Secondary Water Resource Assessment

West Cochrane Gravel Pit

BURNCO Rock Products Ltd.

January 12, 2023

Figure E Test Results from Tetrattech Laboratories

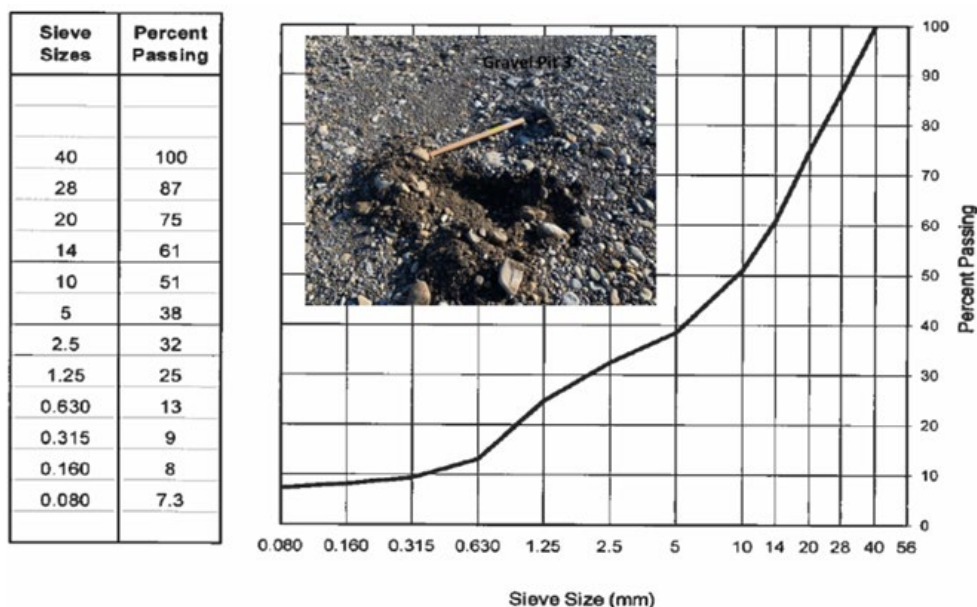
A submission by Dr. Jon Fennell (Fennell, J. 2021) during the municipal hearings in July 2022 reported on the results of a column experiment he performed on a sample of soil from the BURNCO Pit. Dr. Fennell reported high turbidity and inferred that the same condition would happen in the natural groundwater system. The experiment, while well-intentioned, does not reflect actual conditions and overstates the potential impact for the following reasons.

He states in his report that a “mixture of clay, silt, sand, and cobbles was loaded into a pre-cleaned 1.5 m x 51 mm ID PVC pipe to produce a vertical soil column mimicking what would be left beneath the BURNCO pit after mining.” He reportedly tapped the column to induce settlement whereby the soil in the column was 1.2 m deep. This does not mimic natural deposition and will be comparatively unconsolidated; the soil left in place will be of a more compact nature. This method does not mimic natural conditions as claimed. He then filled the column with water and left it overnight. He then added water and sampled the discharge during the next day. The flow rate is not reported, the sample volumes were not recorded, and the time the samples were collected was not provided. This information would have been helpful in assessing the methodology and reliability of findings.

He reports that he obtained material from the BURNCO property; however, the sampling methodology was not presented. There are accepted ways to representatively sample soils, and it is unknown if his field person was aware of that. Where on the site did the sample come from? Was it in-situ, from a stockpile, from the top or bottom of the stockpile, from a ditch, from the pit face, from the pit floor, etc.? All of these factors influence the nature of the sample and, thus it is unknown if it is truly a representative sample. He has assumed the soil he tested has similar physical and chemical properties as the aggregate materials that will be left in place below the BURNCO Pit. However, this does not appear to be the case, based on his description above of the soil he tested, as the stated presence of fines is not consistent with the aggregate resource. For example, a representative sample from the pit floor collected on behalf of SLR showed silt content (< 0.05 mm) of less than 7 %, as per the test results from Tetrattech Laboratories in Calgary, shown in Figure E.

Dr Fennell does not provide any grain size information, so we cannot compare the two directly, but the material tested by Dr. Fennell, based on his description (quoted above), contained more clay and silt and didn't seem to contain any gravel.

Therefore, it appears that the material tested by Dr. Fennell is not representative of the material being left in place below the BURNCO pit. The higher content of clay and silt in Dr. Fennell's materials is very likely to have resulted in higher suspended sediment and turbidity than would be expected from the almost completely gravel and sand materials being left in place below the BURNCO Pit.

Dr Fennell flushed the column for two days, taking two water samples. In his testing, all concentrations were reduced by about 35% after two days, which implies a simple flushing process of a disturbed sample and not prolonged production of turbidity.

Dr. Fennell reports elevated concentrations of metals in the effluent water. The higher, unrepresentative suspended sediment/turbidity in Dr. Fennell's samples is also the reason for the elevated concentrations of aluminum, arsenic, chromium, cobalt, iron, manganese, and zinc he reports³. This is because the metals analysis he completed included a sampling technique whereby the unfiltered sample was acidified. When an unfiltered sample is acidified, the preservative acid dissolves the sediment within the sample and effectively includes the metals present in the particulate material with the dissolved concentrations. This leads to excessively and unrepresentatively high dissolved metal concentrations. However, given the materials that will be left in place below the BURNCO Pit have very little clay and silt in them, similar increases in suspended sediment/turbidity and elevated metals associated with the suspended sediment/turbidity, as suggested by Dr. Fennell, do not appear likely.

So, the column test carried out by Dr. Fennell potentially used material that is not considered to be representative of the material known to be present, used unknown flow rates and retention times, ceased after only two days when a longer test would have been more representative, and analysed water using a method that overestimated the dissolved metals concentration. Based on this, Dr. Fennell's experiment cannot be relied upon to represent actual conditions.
